**GOVERNMENT OF INDIA
MINISTRY OF RAILWAYS
RESEARCH, DESIGNS & STANDARDS ORGANISATION**

Modification Sheet No. RDSO/2012/EL/MS/ 0418 Rev. '0'

Modification on relocation of BP & FP Angle cock in WAP-1/4 class of Electric Locomotives.

REPOSITIONING OF BP ANGLE COCK IN WAP-1/4 LOCOS

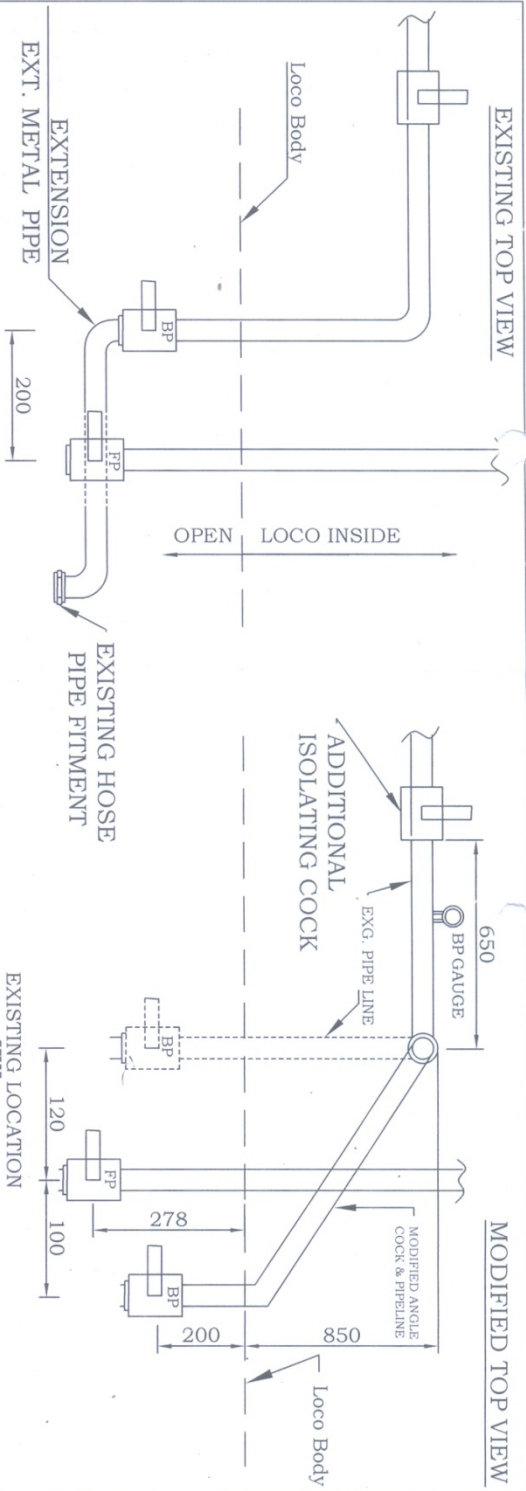
Therefore the breakage of the BP angle cock & extension pipe can be minimized by relocating the BP angle cock. To eliminate the extension pipe, BP angle cock is to be shifted below the FP angle cock at ALP side keeping FP angle cock at the same location.

- ❖ Remove BP hose, BP extension pipe & BP angle cock.
- ❖ Unclamped the BP pipe & safety brackets.
- ❖ Disconnect the BP pipe line after additional isolating cock.
- ❖ Re-route the existing BP pipe line below the FP angle cock just above cattle guard at a location where vacuum pipe was connected as shown in drawing enclosed.
- ❖ Properly Clamp the BP pipe line if additional holding clamp is required.
- ❖ Reconnect the BP angle cock. The existing opening in buffer beam & cattle guard for vacuum pipe is to be utilized for re-connecting BP angle cock as shown in drawing enclosed.
- ❖ Reconnect the BP hose pipe. Ensure fitment of re-located BP hose pipe on dummy hose pipe bracket on cattle guard.
- ❖ Properly stenciled the BP angle cock location. Ensure proper colour coding of BP angle it should be '**Green**' and stenciled as BP.

- ❖ Ensure there should not be any infringement with CBC coupler operation and also ensure diagonal connection of BP hose pipe with stock and with existing as well as with modified locomotives.
- ❖ The safety bracket for protection of BP angle cock, against damage in case of external hitting due to cattle run over is to be provided as recommended vide modification Sheet No. ELRS/MS/0270/Rev.'0' dated 08.11.1999.
- ❖ Though FP angle cock will remain at same location but ensure FP angle cock is to be painted 'White' and stenciled 'FP'.

- NOTE:**
1. ALL DIMENSIONS ARE IN MM.
 2. EXISTING ARRANGEMENT IS SHOWN IN DASHED LINE.
 3. THE COLOUR OF BP & FP ANGLE COCK SHALL BE GREEN & WHITE RESPECTIVELY.
